CLIO II

THE VEHICLE WILL NOT START

Cancels and replaces Technical Note no. 3380A from FEBRUARY 2000

Modifications: Vehicle fabrication cut-offs and After-Sales solutions

Fig. 1

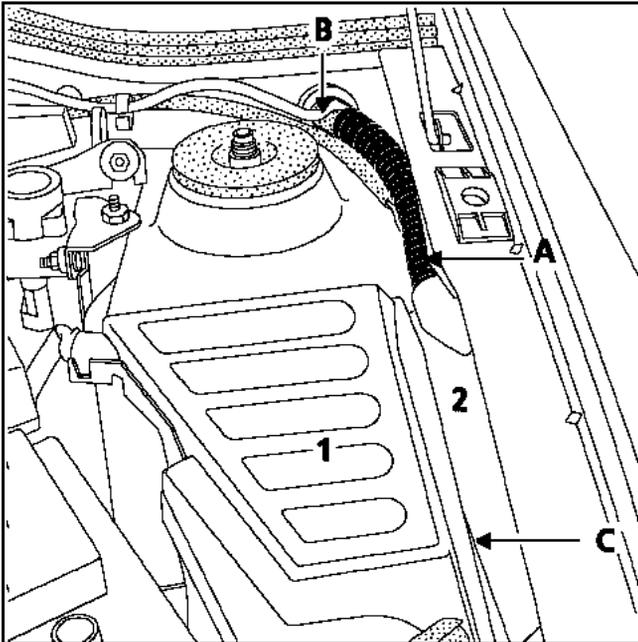
- 1 Repair or replace the corroded relay connector.
- 2 Fit a 23 mm diameter grooved sheath, 160 mm in length (A) (Fig. 1). This sheath should be fitted tight against the fuel cut-off switch wiring (B) (Fig. 1) with the slot facing downwards. Surround the sheath with adhesive tape along its length, starting from the fuel cut-off switch wiring.

- A - Grooved sheath (L=160 mm)
- B - Code and inertia switch wiring
- C - Cover closure areas (1) and (2) to be checked

Fig. 2

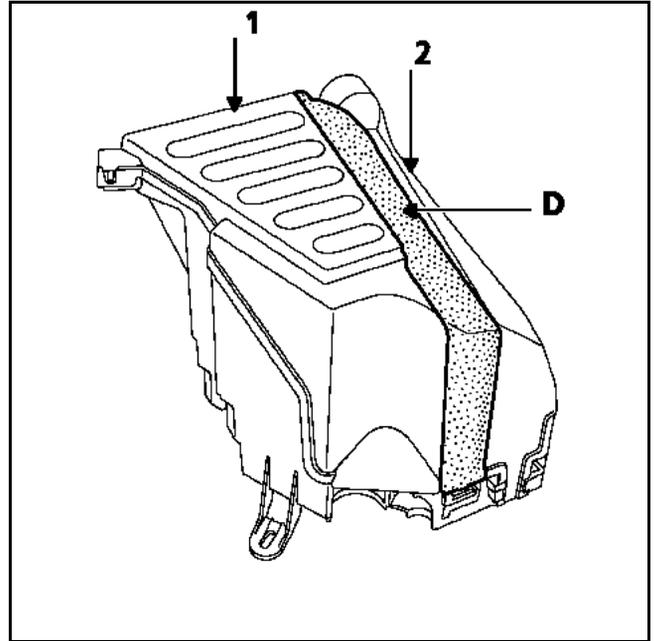
- 3 Check the engine interconnection unit sealing ring. Affix a strip of adhesive tape, Part number: 77 01 051 685, (D) (Fig. 2) to the cover closure areas (1) and (2) (Fig. 2).

- D - Adhesive tape
